<b>digital</b>	<b>FIELD SERVICE TECHNICAL MANUAL</b>				Option or Designator
	12 Bit <input checked="" type="checkbox"/>	16 Bit <input checked="" type="checkbox"/>	18 Bit <input type="checkbox"/>	36 Bit <input type="checkbox"/>	AD01

Title AD01 MULTIPLEXER F.E.T. Leakage				Tech Tip Number AD01-TT-1	
All Processor Applicability			Author R. Adams	Rev 0	Cross Reference
8's	11's		Approval J. Blundell	Date 12/07/72

EFFECTS OF MODIFICATION ON GDI LOGIC

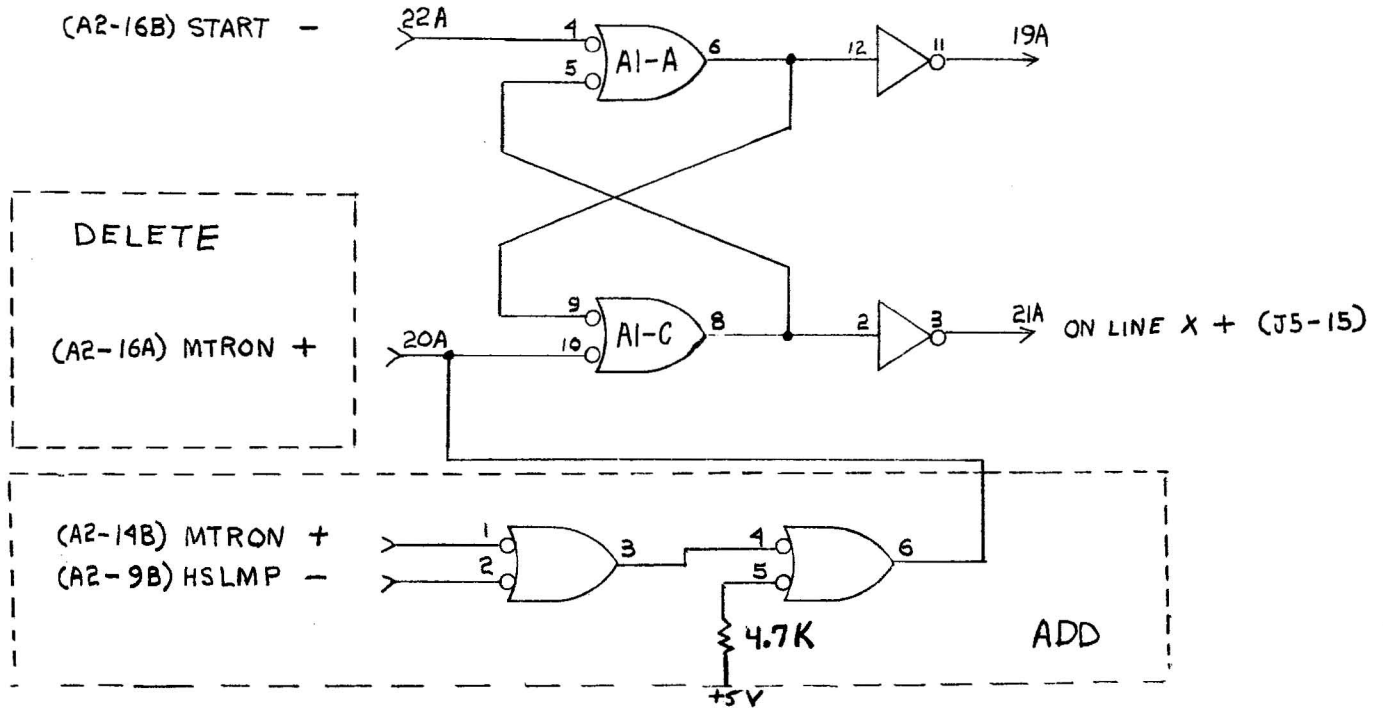
SOLUTION: The only way to correct the problem is to OR the Hopper Empty signal with MTRON + and use the resultant signal for resetting ON LINEX: this can only be accomplished by adding an external component to the existing GDI logic.

The following diagrams will explain the exact nature of the modification.

WAS

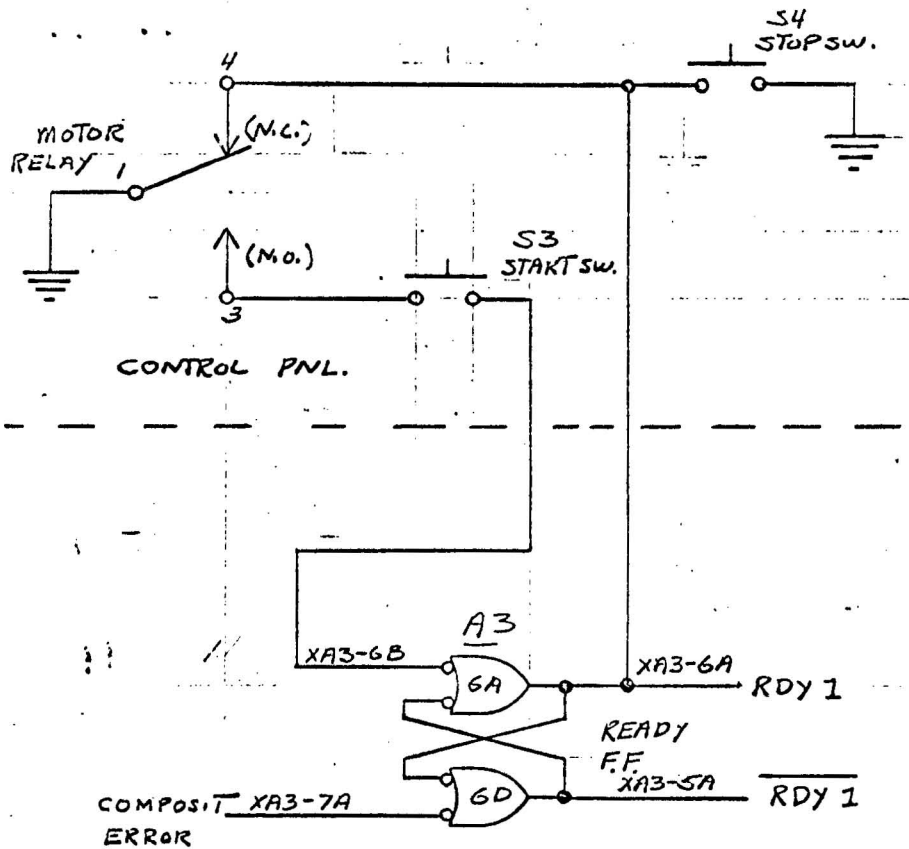
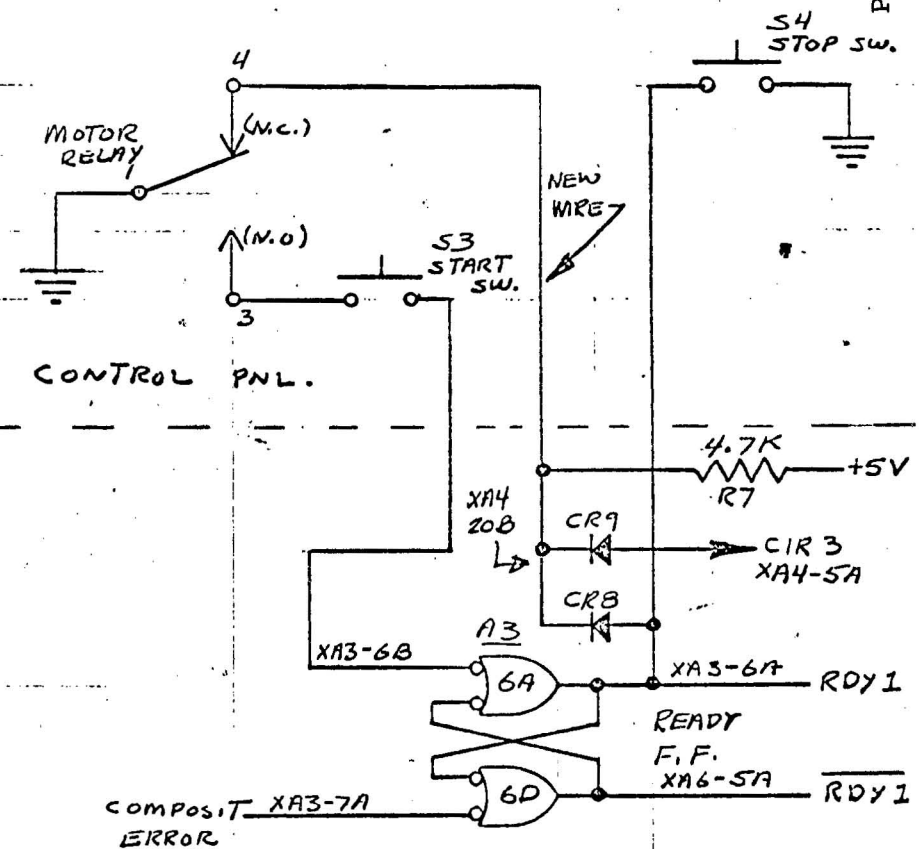
- 1) Open all printed circuits attached to All pins 4, 5, & 6.
- 2) Jumper A3A11-4 to A3-22A.
- 3) Jumper A3A11-5 to A3-21A.
- 4) Jumper A3A11-6 to A3-20A.
- 5) Drill P.C. Board for 6.8K 1/4 W resistor (DEC #13-00463).
- 6) Solder one lead to A3A11-4. The other end solder to +5 volt and from A3-31A.
- 7) Add 101 after assembly.
- 8) This redesigns the stacker fail circuit and creates an extra "and" gate in A3A11.

THIS WIRING CHANGE WILL PREVENT ANY SIGNAL OUTPUT FROM THE "CIR 3" (CARD IN READER SIGNAL) WHEN POWER IS TURNED ON. CRB PROVIDES THE RESET TO THE READY F.F. FROM THE MOTOR RELAY AND ISOLATES THE STOP SWITCH. CR9 PROVIDES THE CIR 3 CLAMP LOW DURING POWER ON AND WILL HOLD THE LINE LOW UNTIL THE MOTOR IS STARTED. R7 PROVIDES A PULL UP TO REVERSE BIAS CRB & CR9 WHEN THE MOTOR RELAY OPERATES.

THIS CHANGE REQUIRES AN ADDITIONAL WIRE FROM THE CONTROL PANEL TO THE CARD FILE. CONNECTOR XA4 PIN, 20B MAY BE USED AS A TIE POINT FOR THE WIRE, CRB, CR9 AND R7.

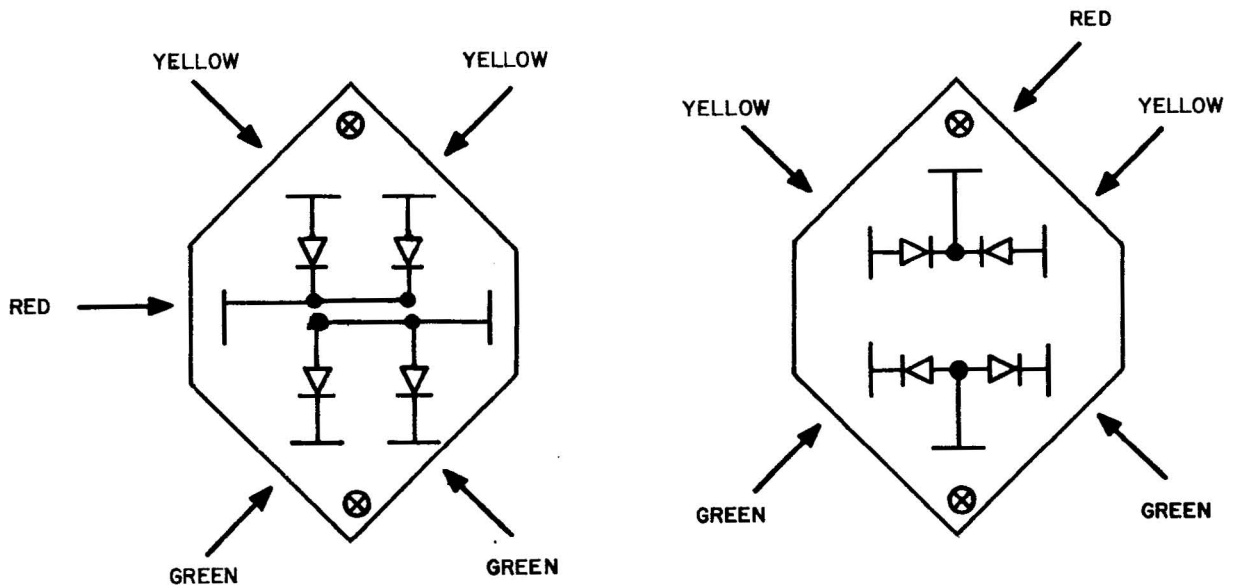
The M633 uses a DEC 3639B transistor. It is overworked when driving a DM01 because the VCEO of 6 volts is exceeded by driving 1.5K to -15 volts. This will be evident on RK08's, DF32D's, FPP12's and the like being interface through DM01 multiplexers.

ECO M633-00002 calls for changing the 3639B transistors to DEC 6534B. This transistor has a VCEO of 40.

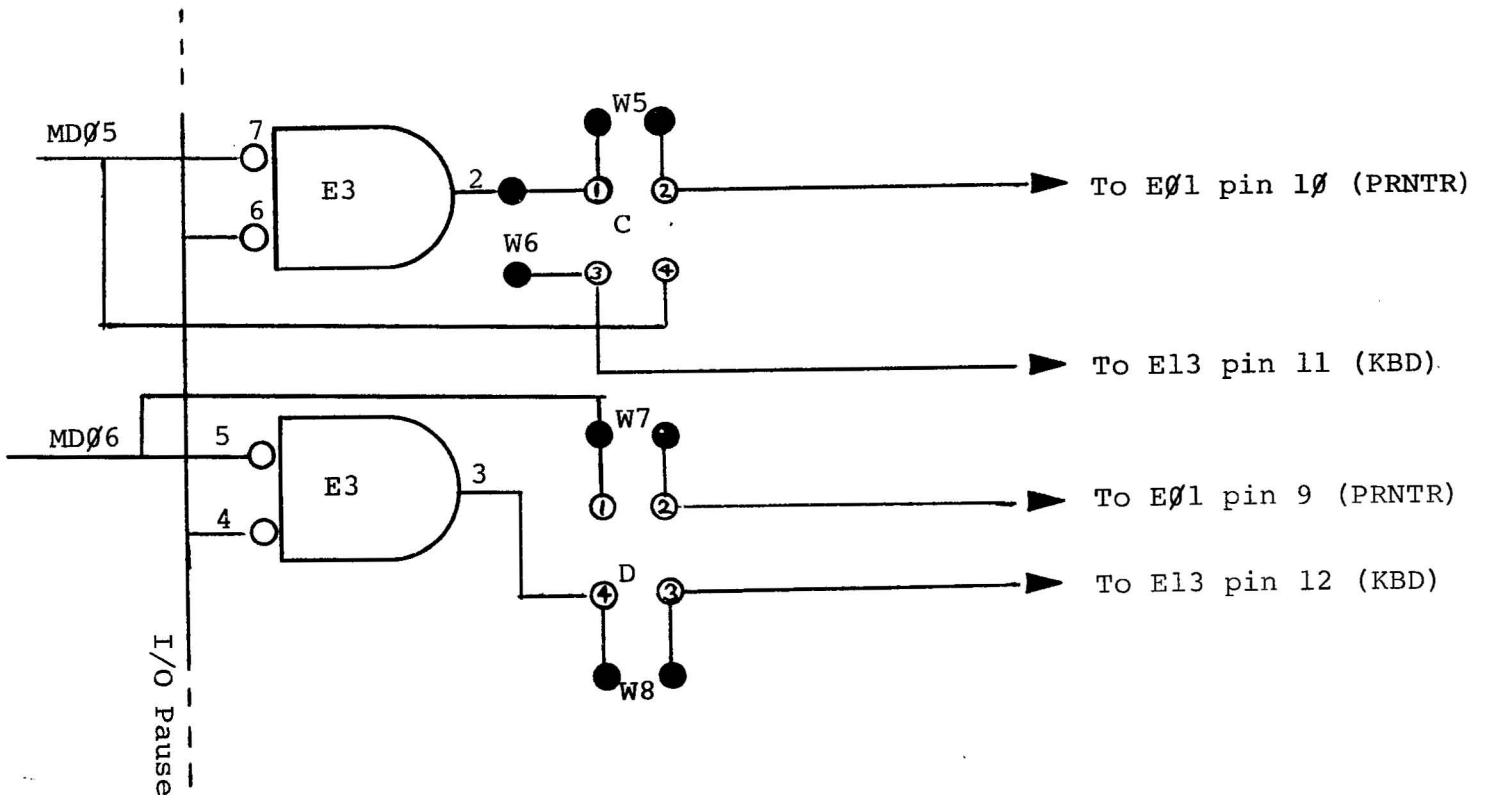
The fault symptom will typically be either wrong sense of bits 5 or 6 in the decoded IOT, or MD bit 6 always constant on the omnibus.

The same mistakes have been carried over into the LS8E (M8342) control. The drawing below also applies exactly to the C.S.Rev.0 of that board.

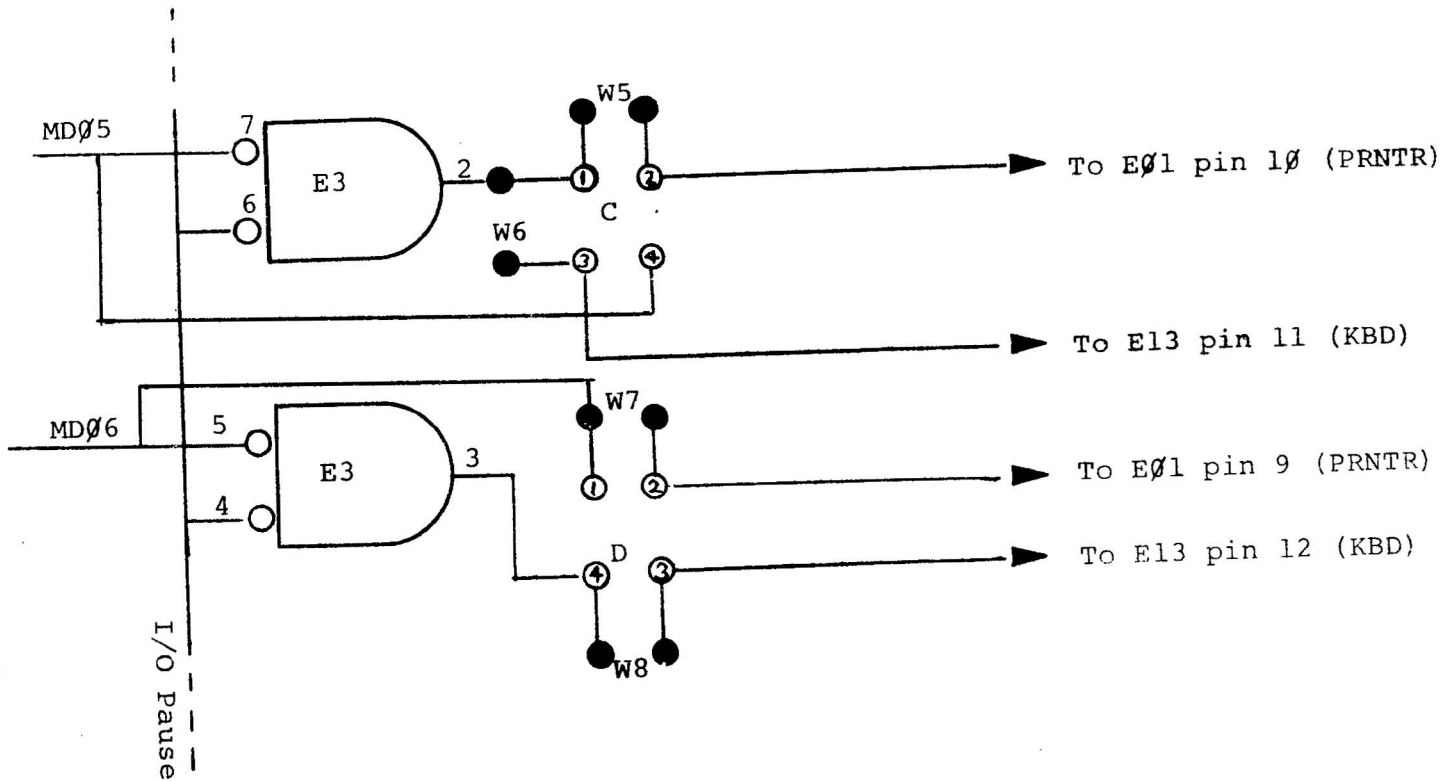
The fault symptom will typically be either wrong sense of bits 5 or 6 in the decoded IOT, or MD bit 6 always constant on the omnibus.

The same mistakes have been carried over into the LS8E (M8342) control. The drawing below also applies exactly to the C.S. Rev. 0 of that board.

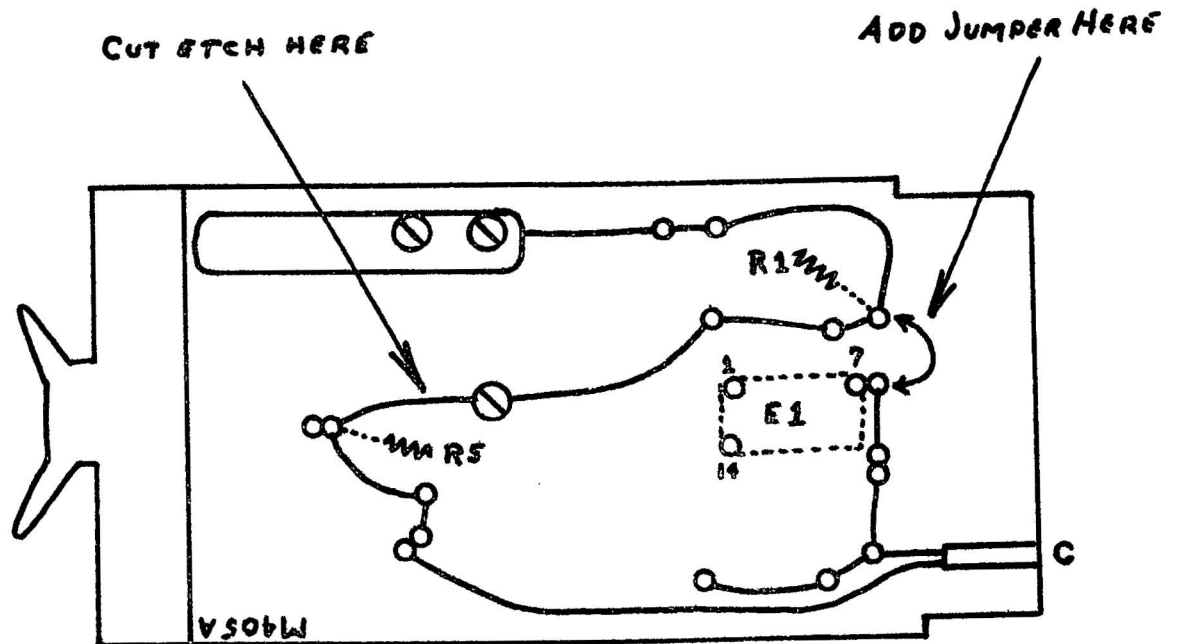
#### METHOD TO OBSERVE GAP USING DELAYED SWEEP

Channel 2 = timing track pulses.

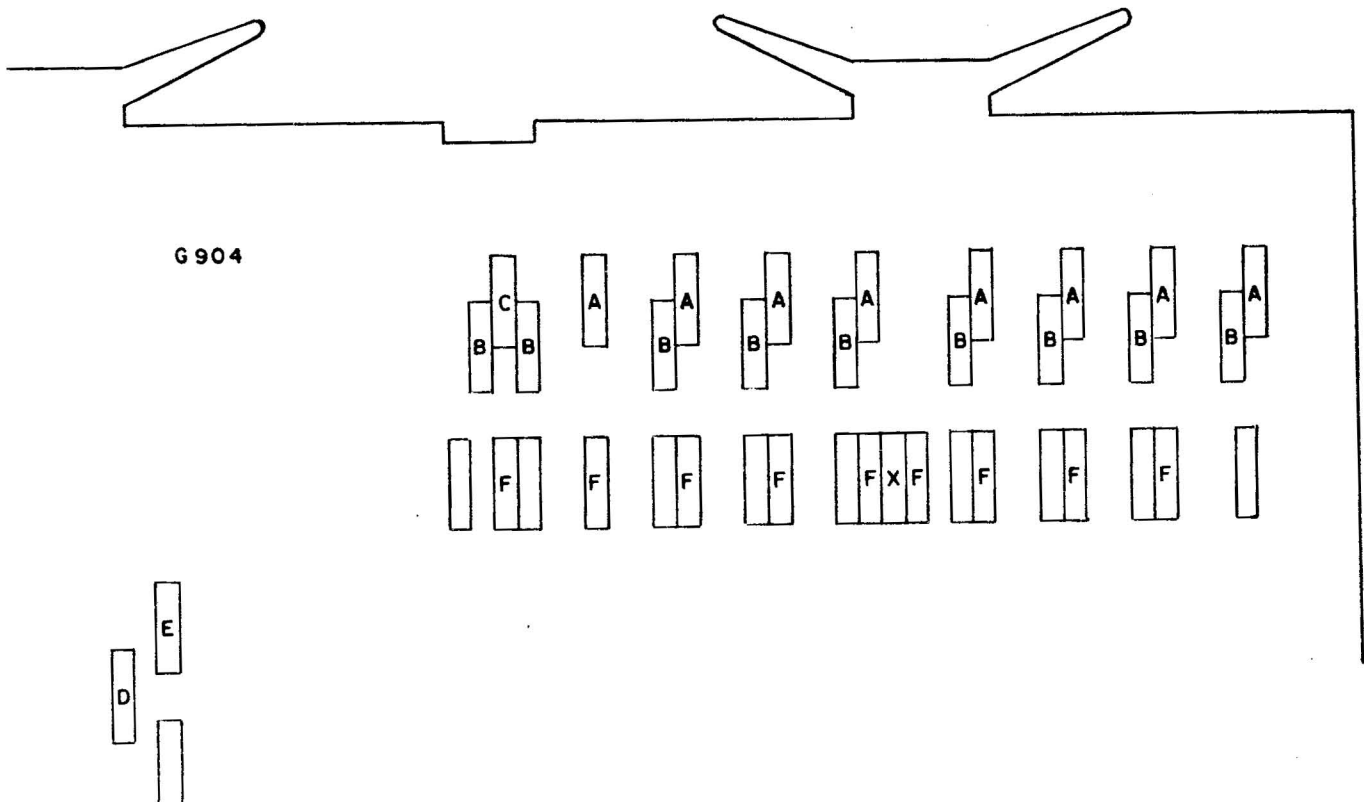
- C. Another problem in the new type TTW is a ground loop. The ground run between the data/timing connector block and the logic connector blocks must be removed. A ground run from the data/timing connector blocks should be made to one of the front panel holding screws on the chassis.
